**Re: Seacoast Reliability Project - SEC Docket 2015-04
Notification of Minor Construction-Related Changes
Submarine cable and Eastern Shore Landing**

LIST OF FIGURES

Newington Cable Landing and Slope Restoration

SEACOAST RELIABILITY PROJECT
 LITTLE BAY, NH
 NEWINGTON CABLE LANDING AND SLOPE RESTORATION, PLAN VIEW
 Date: 04/09/2020
 Project No: 23840.039
 Scale: As Shown
 Drawn By: DLP
 Review By: SDA

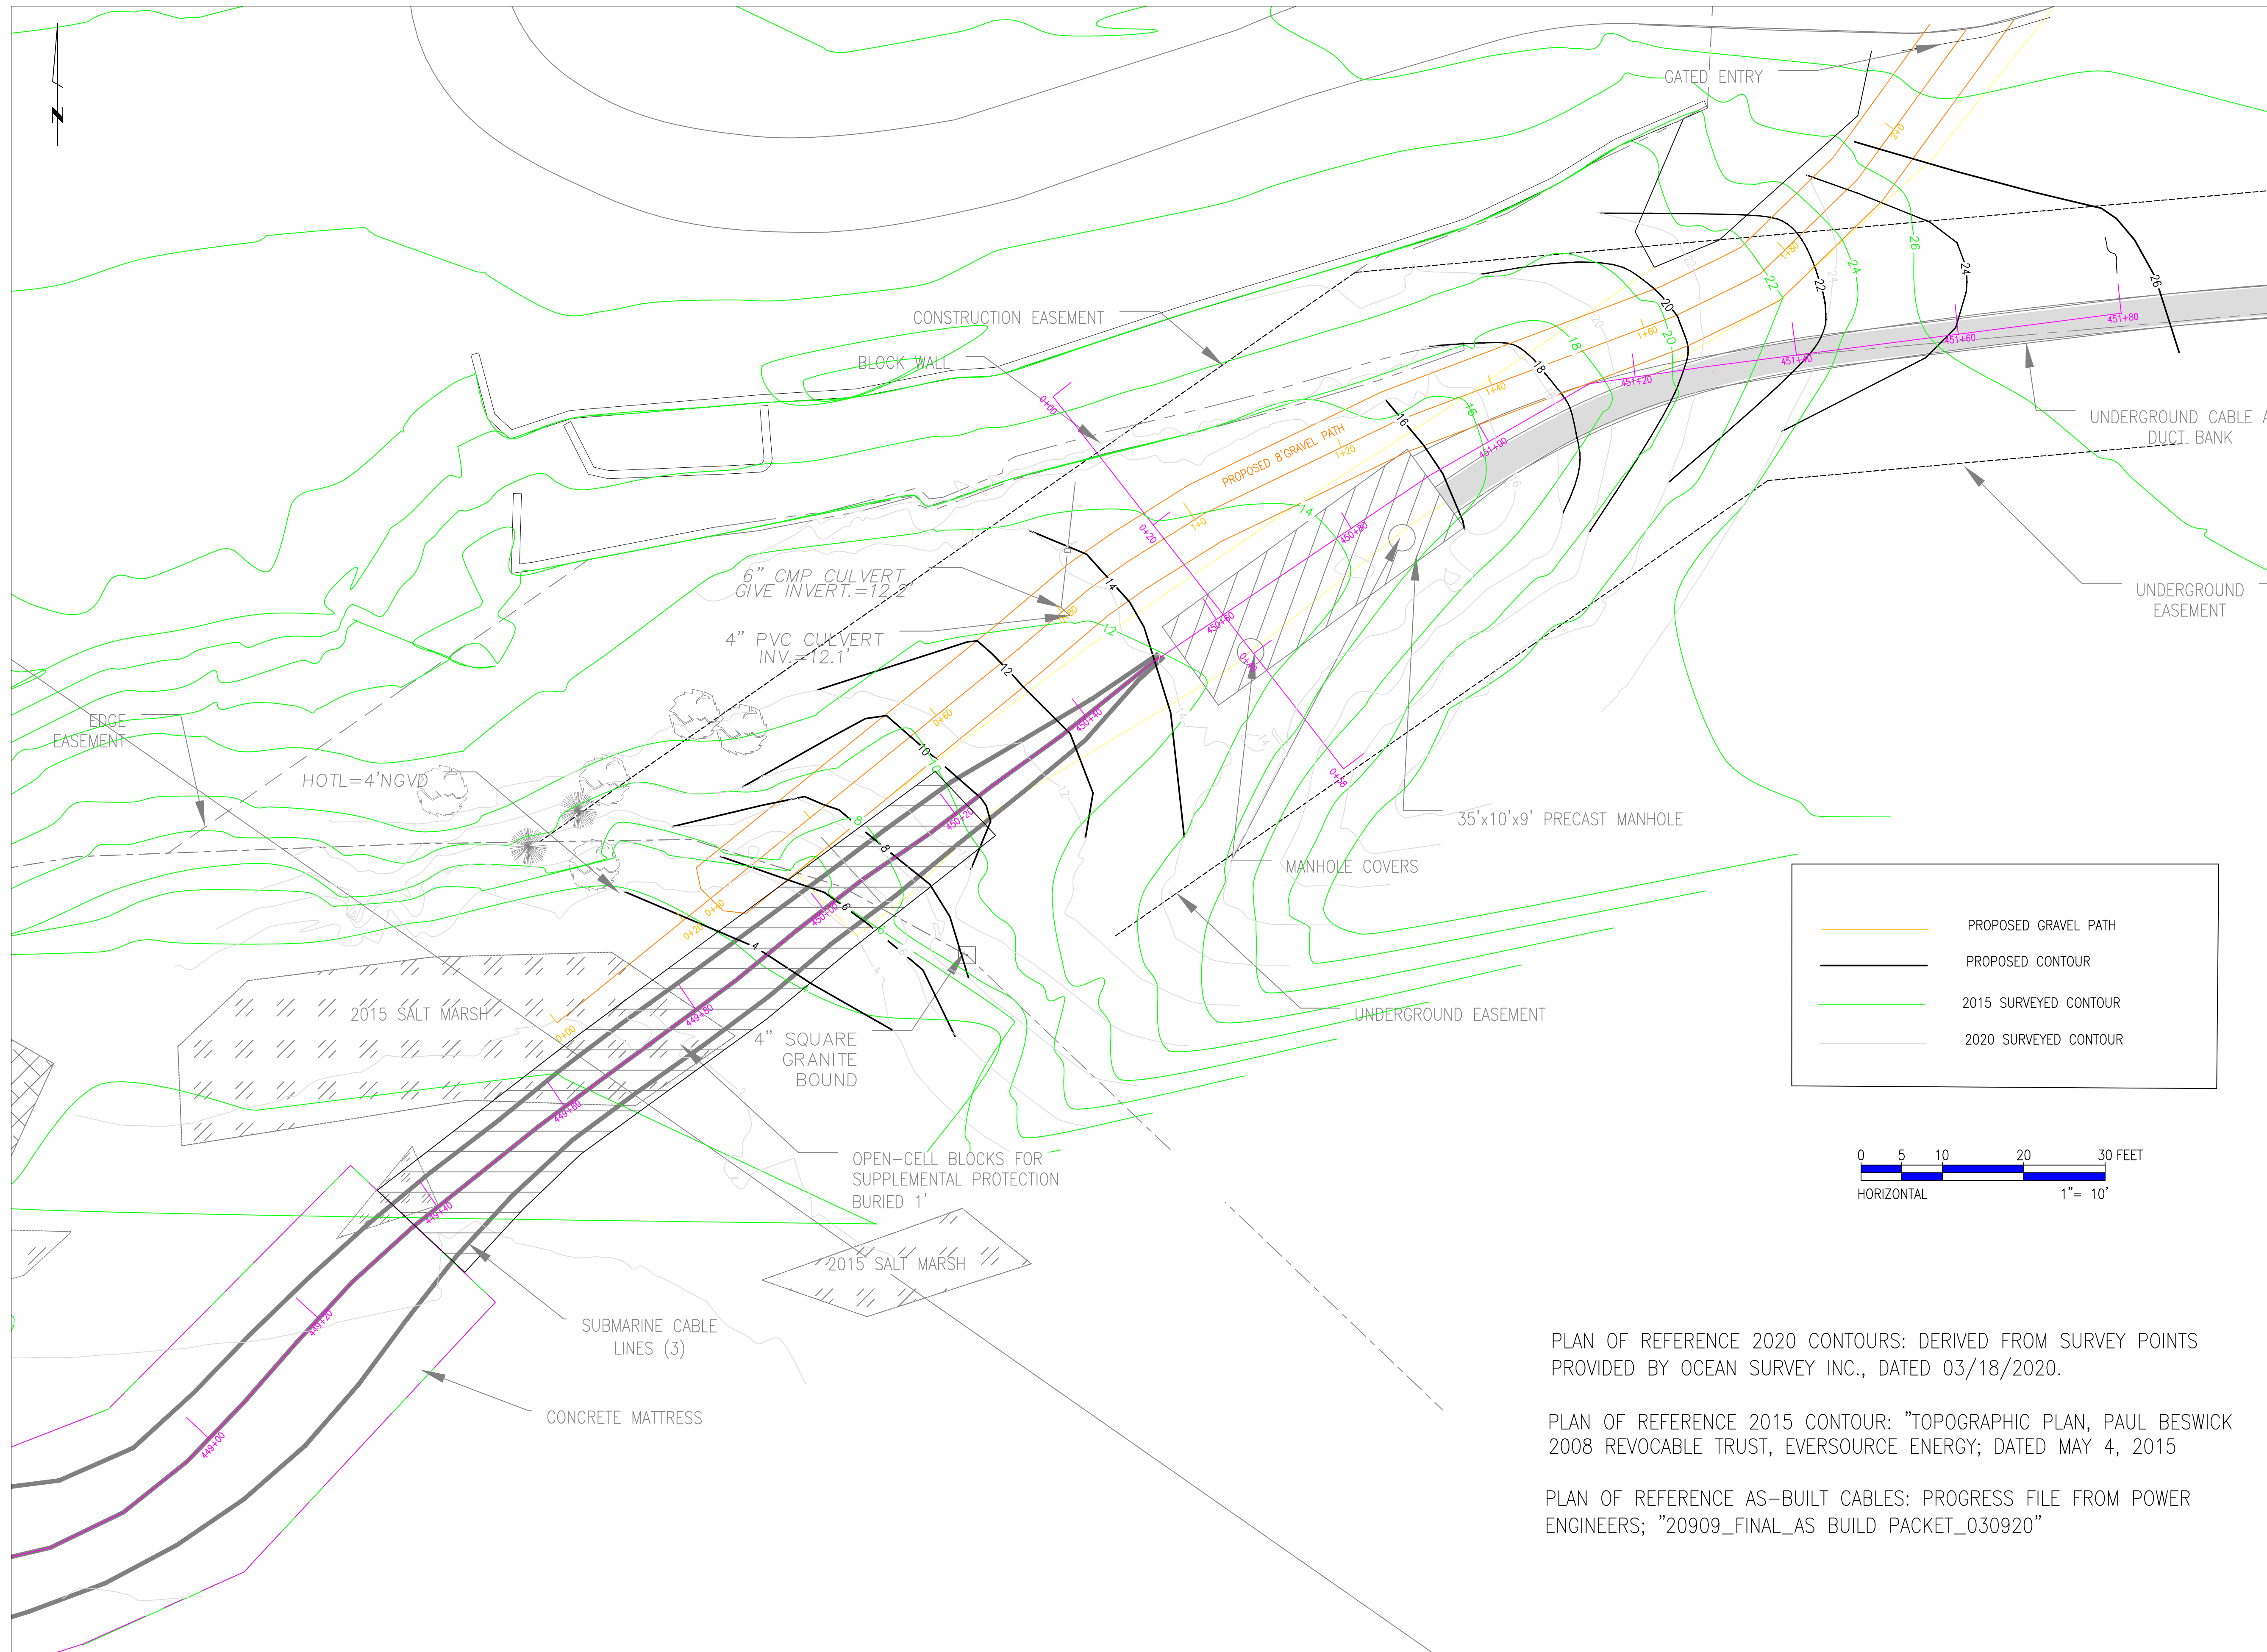
Based on the survey data, the cable contractor has determined that an area approximately 60' in length at the eastern shore below the mean high water line and an area approximately 36' in length above the mean high water line will require additional supplemental protection for all three submarine cables. During construction, cover material was placed on top of the cable above the mean high water line. To finalize construction in both areas, Eversource's contractor must excavate the cover, bury concrete blocks to protect the cable, and establish final grades. More specifically, to meet NESC and SEC requirements, Eversource's contractors will bury 4.75" thick Armortec Armorflex open-cell concrete blocks to a target depth of 12" below grade to protect the cables in the layout shown on the attached plan set entitled *Newington Cable Landing and Slope Restoration*.

Final grades on the property will be controlled by the elevation of the manhole, the toe of slope and the amount of cover or supplemental protection that is required to protect the cables. Stormwater management is also a consideration, due to the sheet flow that drains to the area from the lawn above, and several drains from the driveway that discharge on the north side. The grades shown on Sheet 1 of the *Newington Cable Landing and Slope Restoration* plan set address those concerns and match the original 2015 grades in most locations.

The gravel path will be approximately 8' wide and consist of 6-12" of gravel over the subsoil. The existing drain pipes that discharge to the area will remain in place, but shortened or extended as needed to match final grades. The ones that discharge on a steep side slope will have the same coarse gravel finish as is currently in place.
